RESPONSE TO REQUEST FOR ADDITIONAL INFORMATION

**US-APWR Design Certification
Mitsubishi Heavy Industries
Docket No. 52-021**

RAI NO.: NO. 1045-7141 REVISION 3
SRP SECTION: 03.08.05 – Foundations
APPLICATION SECTION: 3.8.5
DATE OF RAI ISSUE: 07/08/2013

QUESTION NO. 03.08.05-49:

Figure 3.8.5-5 R/B Complex Basemat Foundation, ~~PCCV, and Containment Internal Structure Basemat Foundation~~

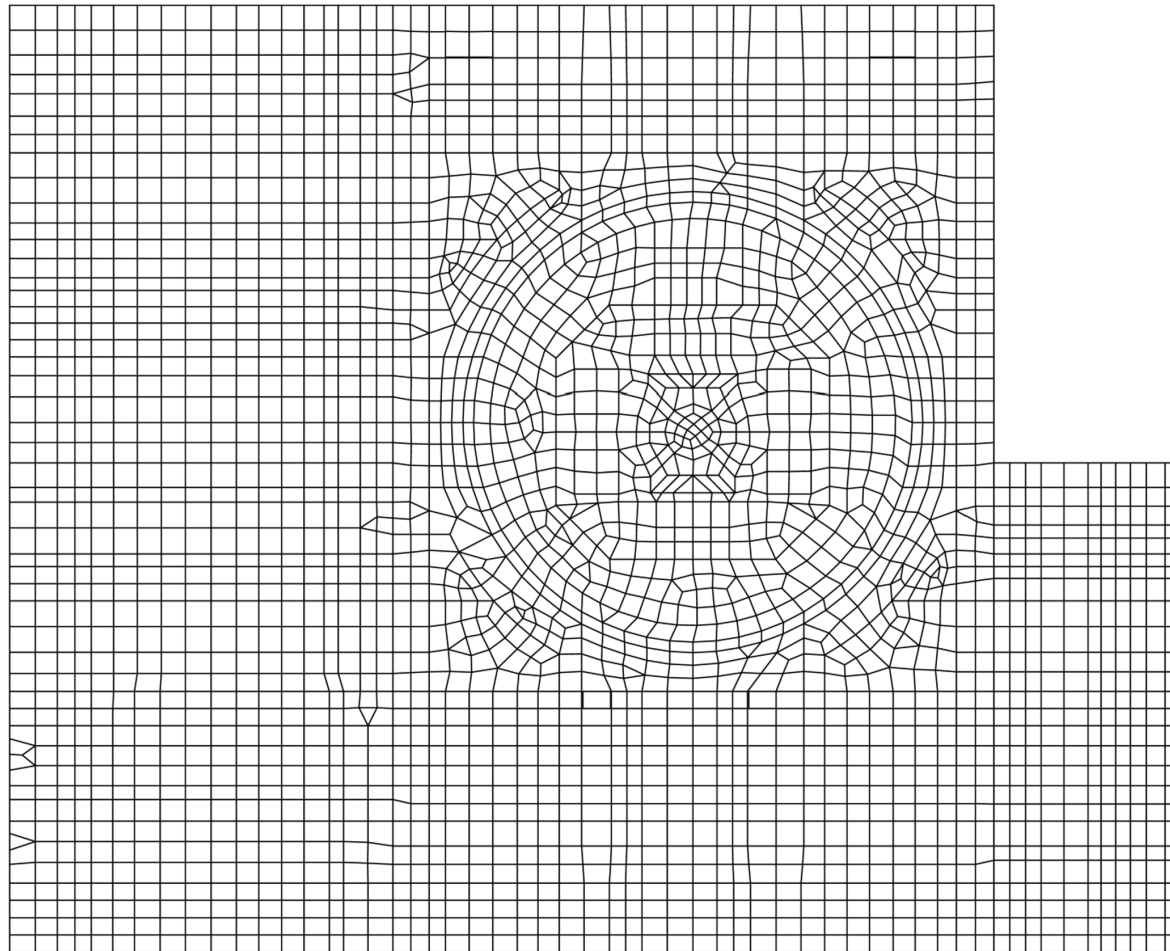
The figure caption of Figure 3.8.5-5 shown in DCD Page 3.8-297 is "R/B, PCCV and Containment Internal Structure Basemat Foundation."

The staff notices that the basemat foundation shown in figure 3.8.5-5 is that of the R/B complex, which includes R/B [reactor building], PCCV [prestressed concrete containment vessel], CIS [containment internal structure], east and west PS/Bs [power source building], ESWPC [essential service water pipe chase] and the A/B [auxiliary building]. Therefore, the figure caption is incorrect. The applicant is requested to correct the figure caption.

The caption for Figure 3.8.5-5 has been revised. See Attachment 1.

The caption of Figure 3.8.5-5 will be revised as shown in Attachment 1 of this RAI.
